BENTLEY BULLETIN # 09-026
To: Parts & Service
From: Fixed Operations
Subject: Recall Campaign - Rear Seat Belt Guide Bracket - RE09/01

09-01-08-01

Centre rear seat belt guide bracket – optional full width rear seat incorporating adjustable outer seats – under specified guide bracket – RE09/01

Applicability: Continental Flying Spur & Continental Flying Spur Speed – see attached VIN list

Figure 1

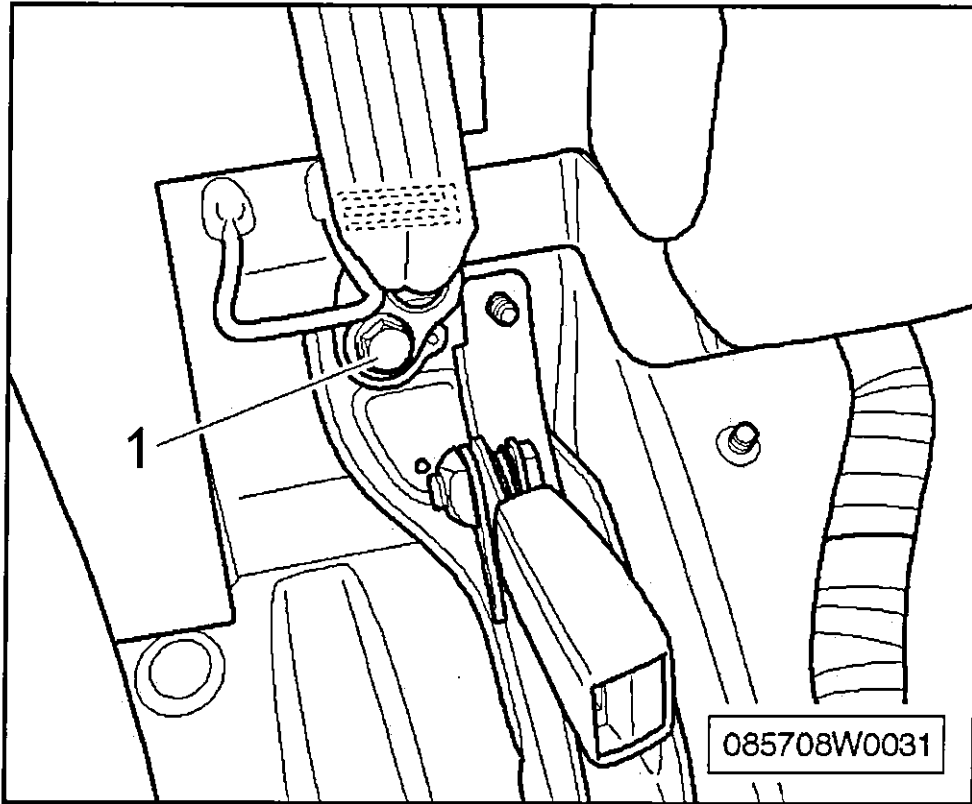
1. Remove the rear seat cushion (Refer to ASSIST BIN 0885)
2. Referencing Figure 1, remove the lower seat belt anchor fixing (1)
3. Remove the rear seat squab (Refer to ASSIST BIN 0885)

Figure 2

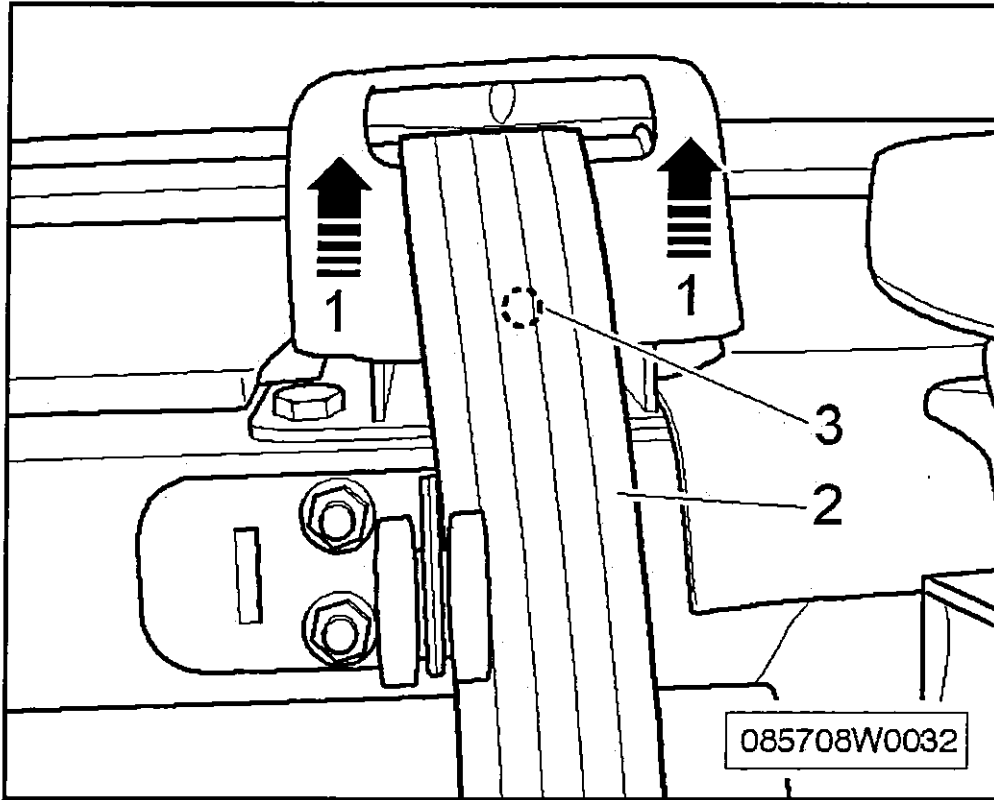
4. On the leather trimmed seat belt tower adjacent to the parcel shelf, pull forward and disengage the escutcheon finisher that the seat belt slides through, pull the belt aside (2) to expose the single plastic fir tree fastener (3) remove the fastener using a suitable tool. Then firmly pull up in the trimmed seat belt tower in the direction of the arrows (1) (there are two downward facing metal clips that retain the trimmed seat belt tower to the seat belt bracket)

Figure 4

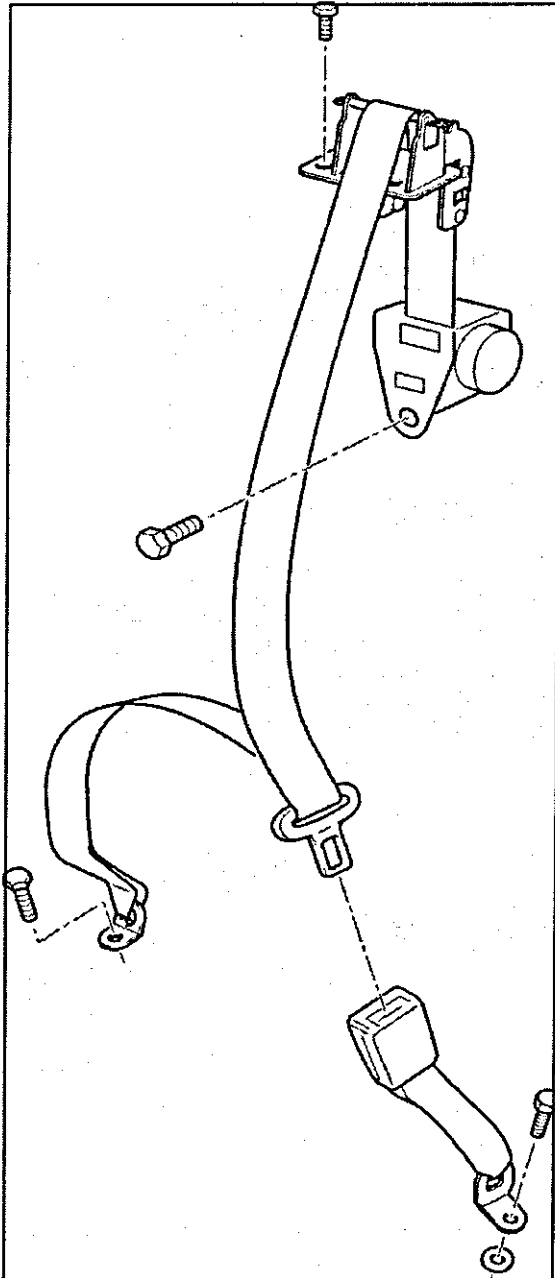
7. Feed the seat belt webbing through the new bracket (part number 3W5857859B) before positioning and engaging the bracket onto the rear parcel shelf (see Figure 4)
8. Torque tighten the two seat belt upper guide bracket mounting bolts. Torque 7/16 UNF bolt to 40Nm
9. Fully extend and retract the webbing to ensure it is not twisted
10. Refit the escutcheon finisher prior to refitting the cover and trimmed tower cover
11. Refit the rear seat squab (Refer to ASSIST BIN 0885)
12. Referencing Figure 1, refit the lower seat belt anchor fixing. Torque 7/16 UNF bolt to 40Nm
13. Refit the rear seat cushion (Refer to ASSIST BIN 0885)
14. Apply a white paint completion spot to the vehicle body adjacent to the main system battery (see Figure 5)
